ADDENDUM NO. 03 **DATE: 06/22/21**

PROJECT:
Addams Elementary School Building Addition and Modernization
FUSD Bid No 22-01

DARDEN PROJECT NO. 1725
DSA File Nos. 02-117220
DSA APPL. NO. 10-48

AD3-AX01

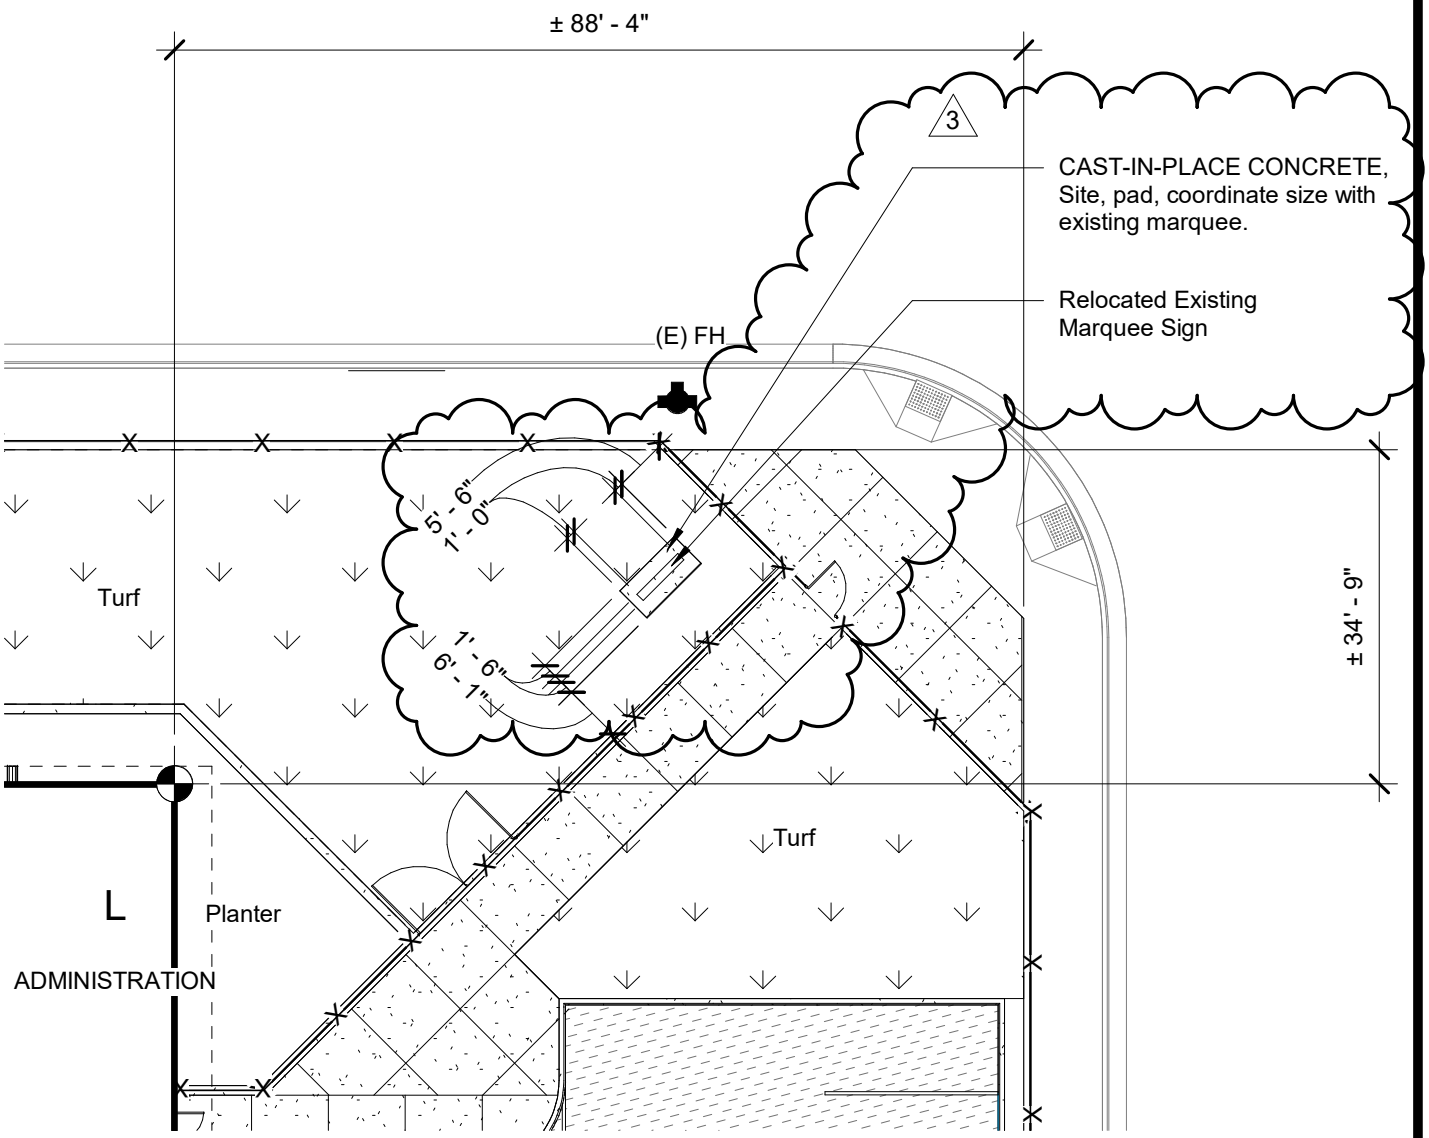
1. Refer to Attached Partial Site Plan AD3-AX01 for required work at relocated School Marquee.
2. Refer to G18- Site Plan Legend, Notes. Add the following:
   a. 7) Once project is complete and Interim housing has been vacated, all Interim housing associated Equipment to be removed and utilities to be pulled back & safely terminated at the closest Christy or pull box.
3. Paint all existing surface mounted electrical conduits and pull cans on the existing MPR to match the building field color.

J11	METAL DOORS AND FRAMES, Louver Head at Metal Stud
3" = 1'-0"

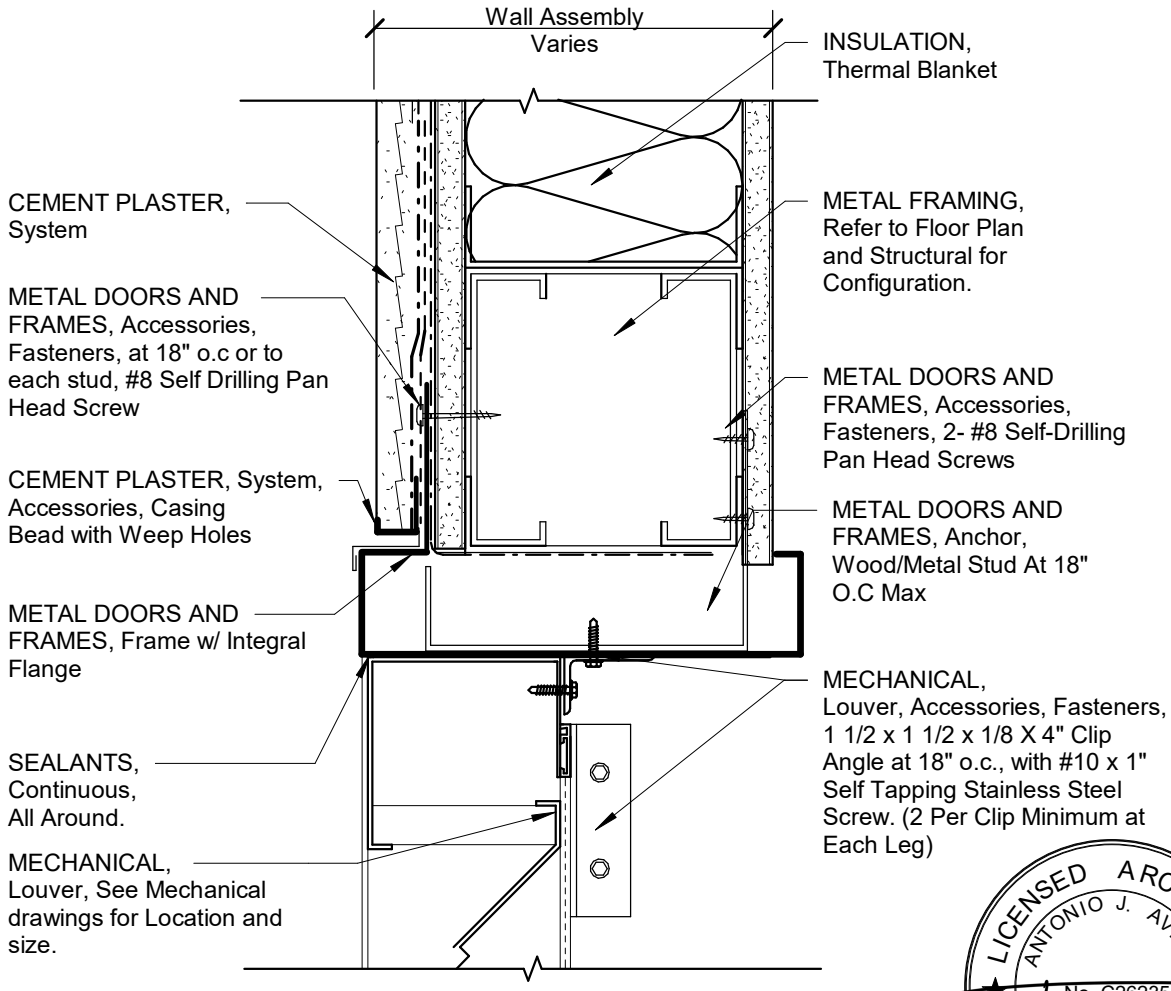
1. Insert the following details for Louvers. Refer to MECHANICAL drawings for Size and locations.
2. Insert the attached Detail AD3-AX02
3. Insert the attached Detail AD3-AX03
4. Insert the attached Detail AD3-AX04

Designed By:	-	Project Number:	1725
Drawn By:	-	Scale:	3" = 1'-0"
Checked By:	-	Copyright 2021 Darden Architects	
Reviewed By:	-	AD3-AX05	
Date:	06/18/21

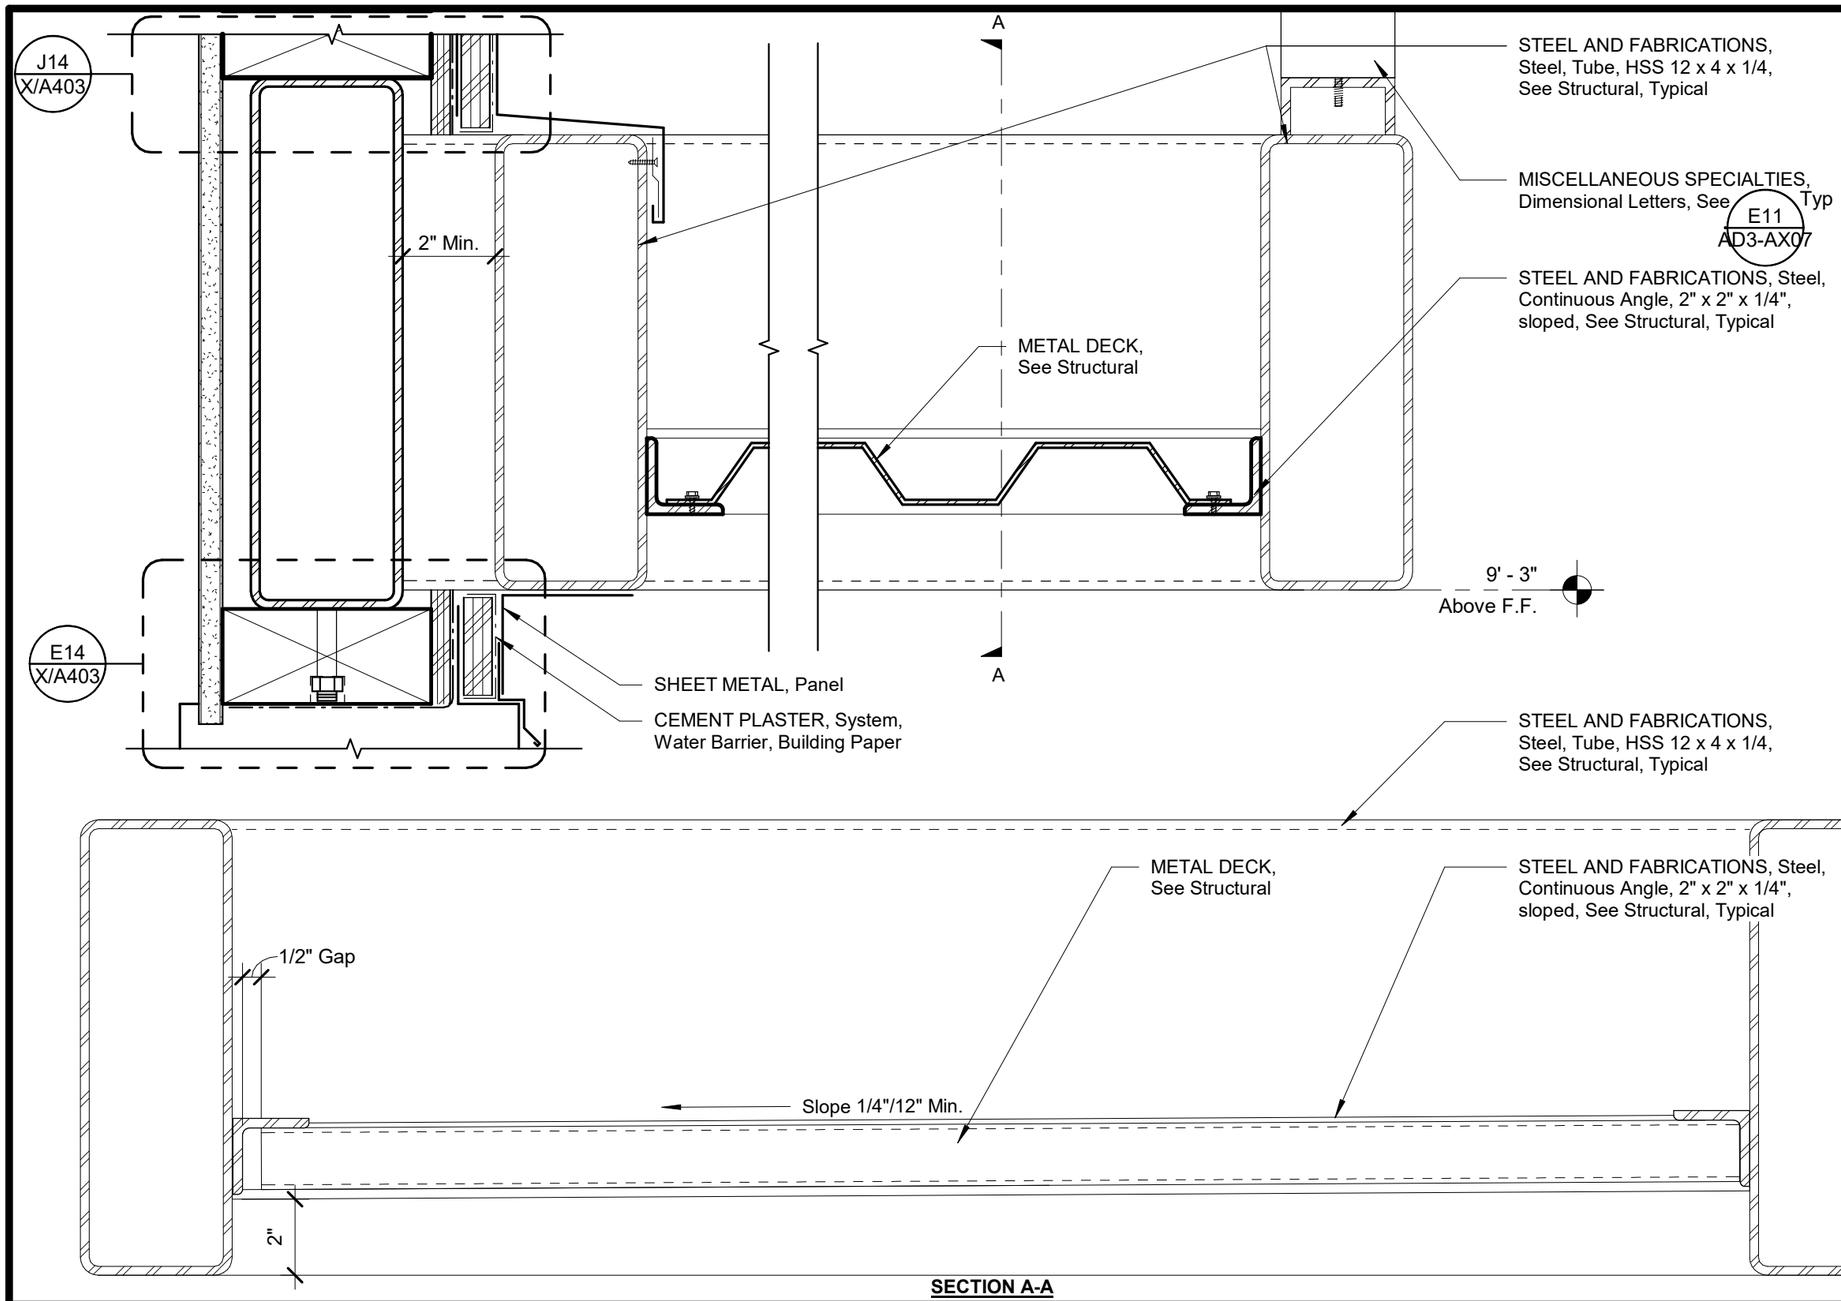
1. Refer to Detail N11 Replace with the Attached Detail AD3-AX05.
2. Refer to Detail A7 Replace with the Attached Detail AD3-AX06.
3. Insert the attached Detail AD3-AX07

Partial Roof Framing Plan (Building B)

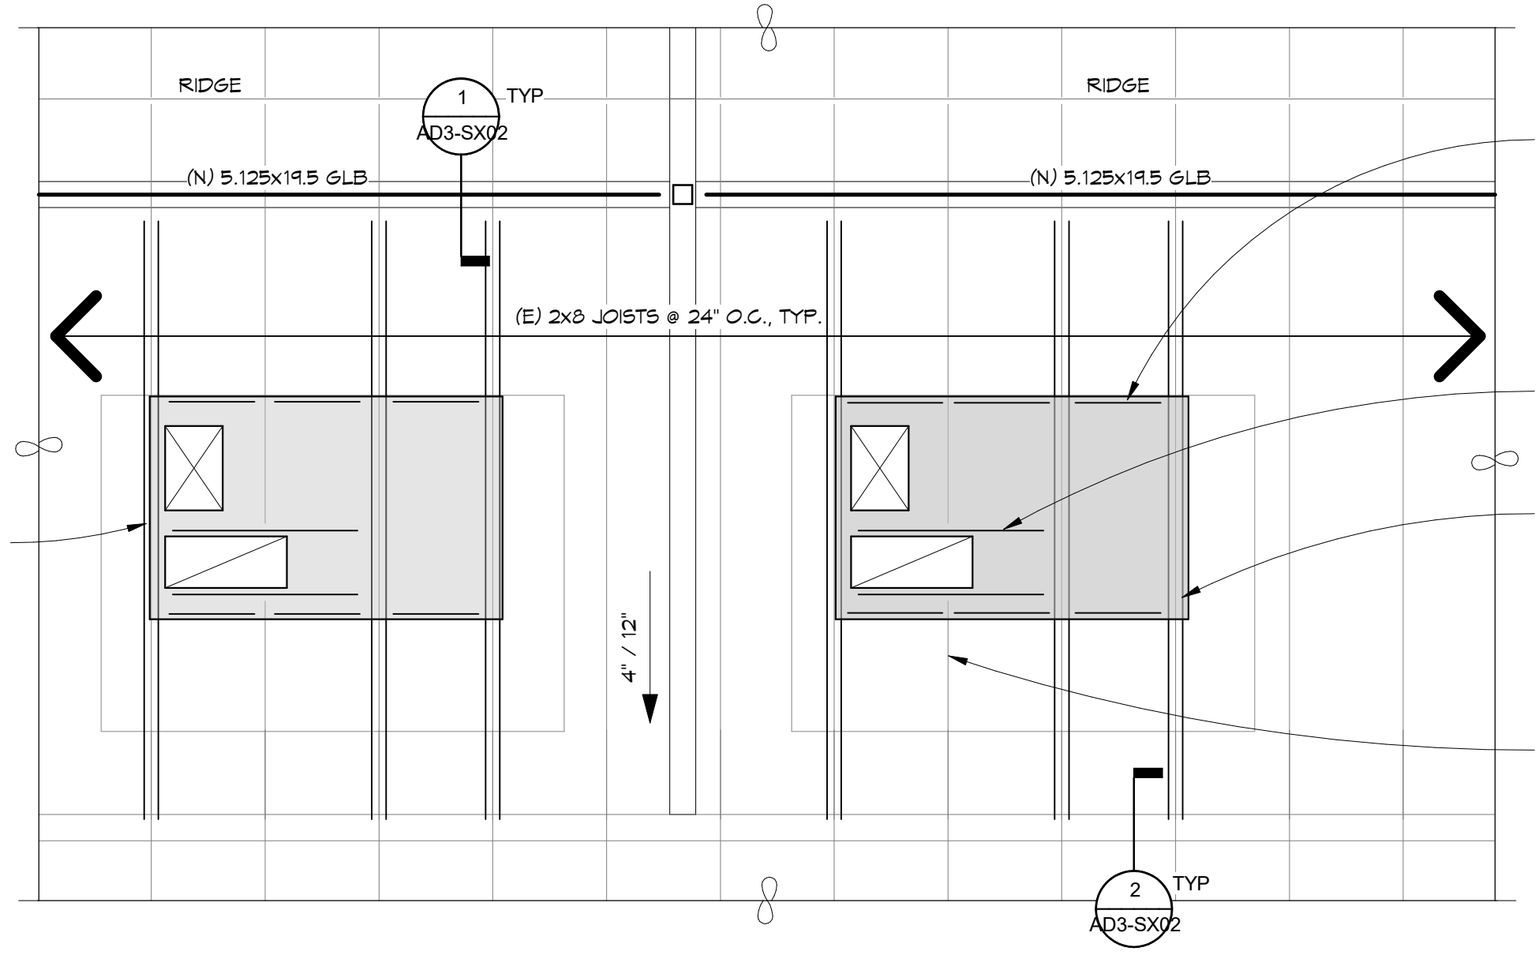
1. Roof framing requirements at Building B have been revised due to a change in the rooftop mechanical unit. Please see attached revised Partial Roof Framing Plan and associated details identified as AD3-SX01 and AD3-SX02.

(N) 4x6 BLKG. AT UNIT PERIMETER W/ SIMPSON HU46 HANGER AT ONE END AND SIMPSON HUC46 HANGER AT OPPOSITE END, TYP.

(N) 4x8 BLKG. W/ SIMPSON HU48 EA. END EA. SIDE OF OPENING, TYP.

(N) 2x8 @ EA. SIDE OF (E) JOIST @ (N) MECH'L UNIT, TYP. FIELD VERIFY NUMBER OF (E) JOISTS TO BE SUPPLEMENTED WITH SUPPLIED MECH'L UNIT. SEE TYPICAL **MULTI-MEMBER CONNECTION DETAIL** (3-PLY CONDITION) FOR ADD'L INFORMATION

(N) HC-4, WT=750# MAX, TYP. (2) LOCS. ANCHOR UNIT TO (N) 4x6 PERIMETER BLOCKING W/ 1/2"Φ THRU-BOLTS AT 24" O.C. MAX. WHERE UNIT EDGE ALIGNS W/ (E) ROOF JOISTS, PROVIDE 1/2"Φ LAG SCREWS @ 24" O.C. W/ 3 1/2" MIN. PENETRATION IN (E) JOIST. CENTER LAG SCREW IN (E) JOIST.

1 Partial HVAC Plan - Building L
1/4" = 1'-0"

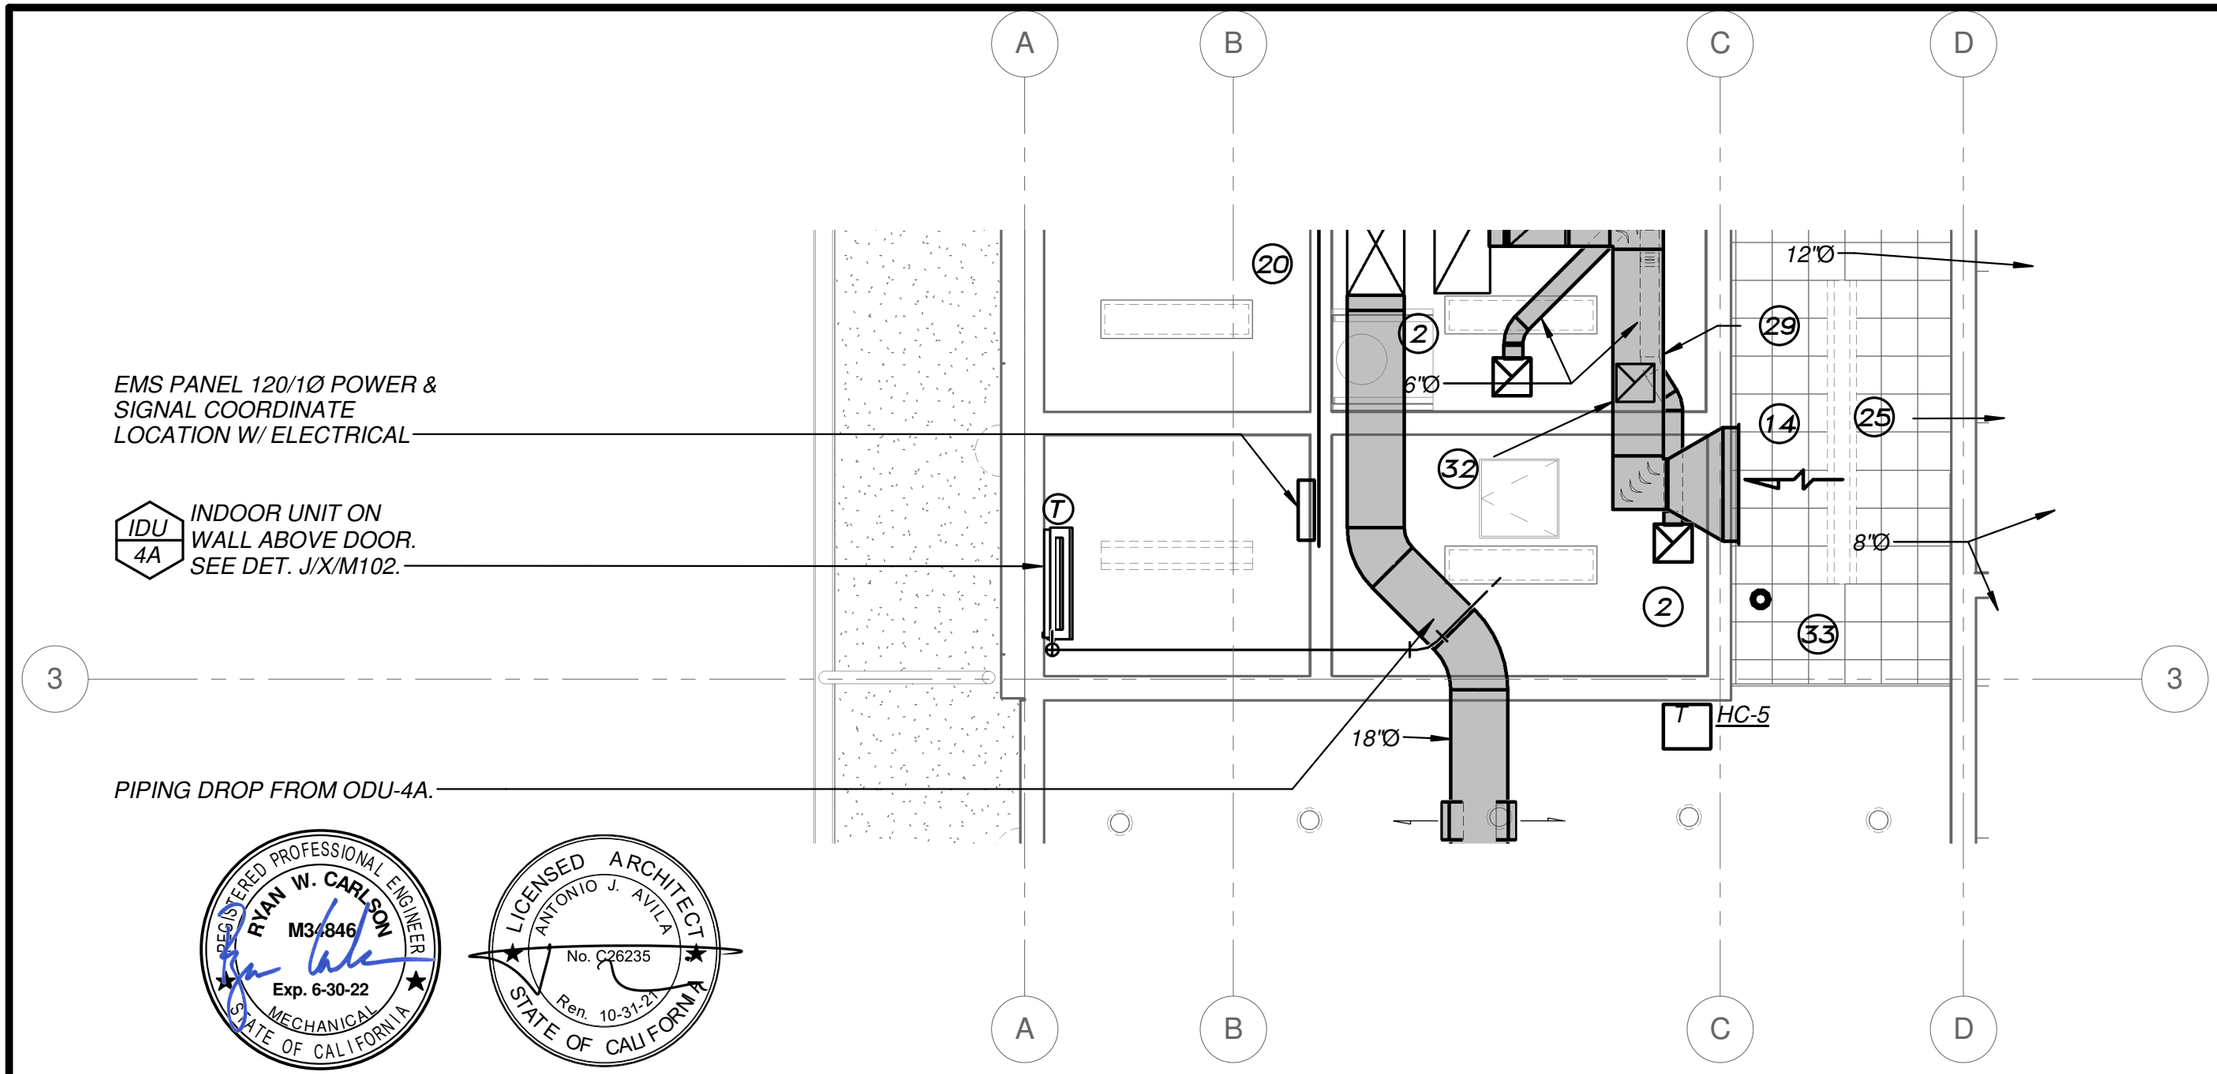
1. Change EF-2 to EF-6
2. Change Keynote #28 to Read EF-7
3. Refer to addendum drawing sheets AD3-MX02 for addition of IDU-4A to Electrical Room 115 (new location for main EMS panel).
